**Landmarks & Urban
Conservation Commission**

**Agenda Number: 4
Case No.: 17-LUCC- 50001
Project # 1011116
March 8, 2017**

Supplemental Staff Report

EAST ELEVATION

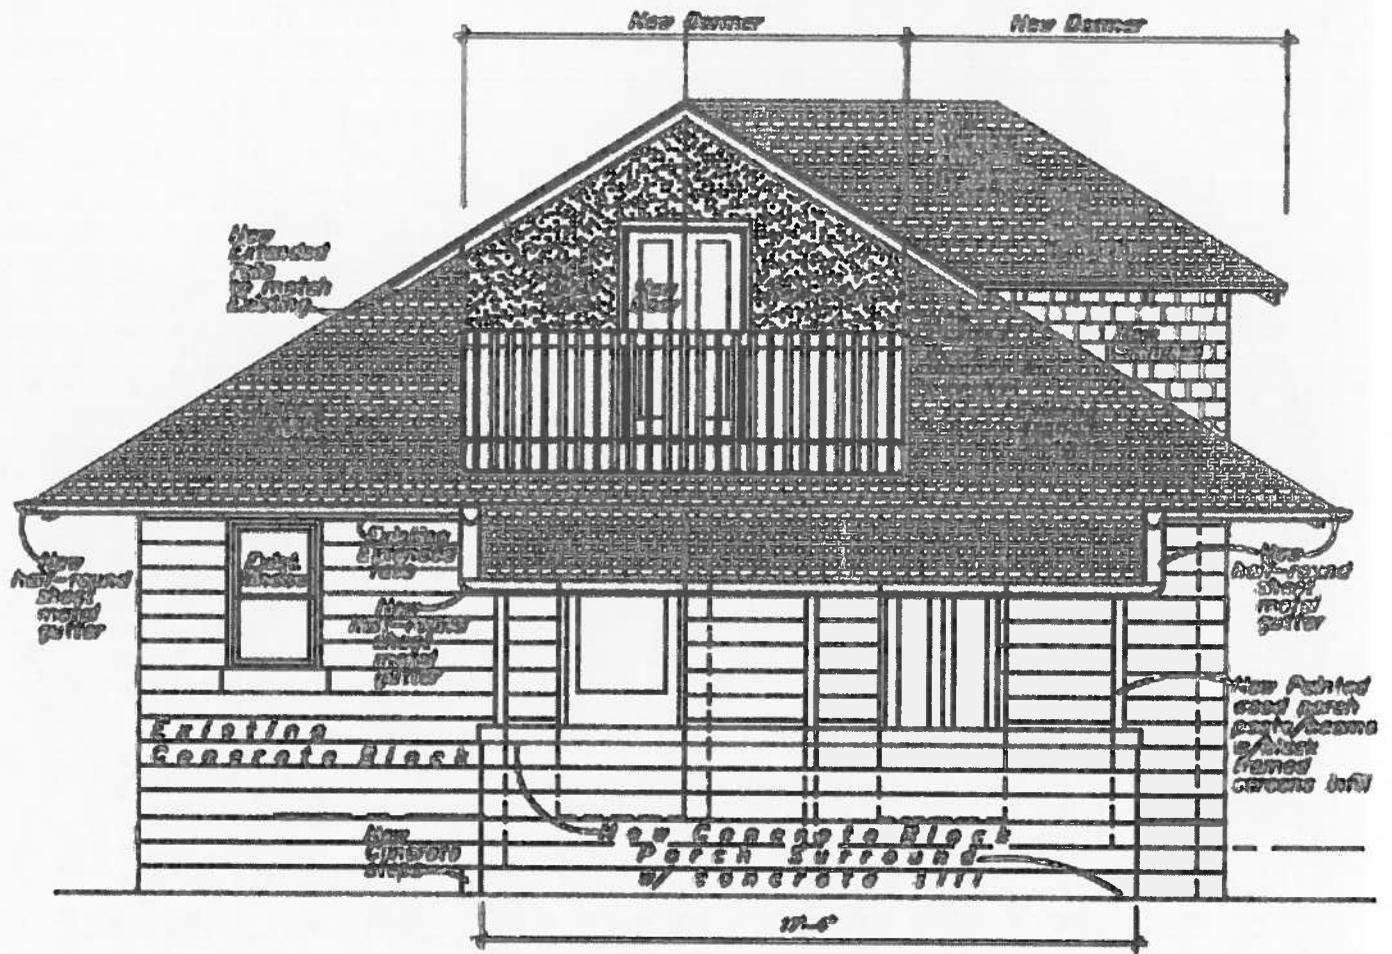
*Refer to Sketch in Submitted packet photos
for more accurate view from front sidewalk/street*

Attachment: A-3

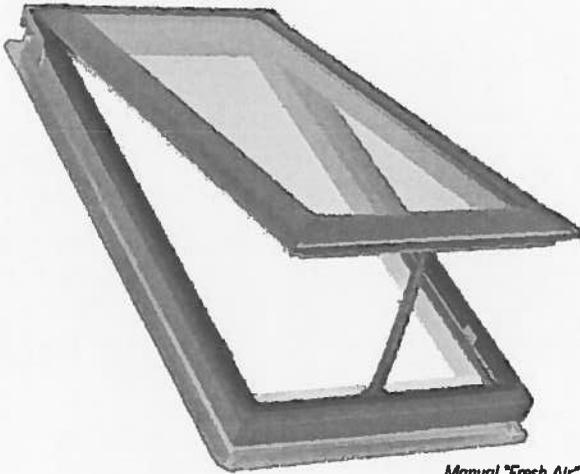
The applicant is also including the addition of an operable skylight to be in the dormer roof but not visible from the street.
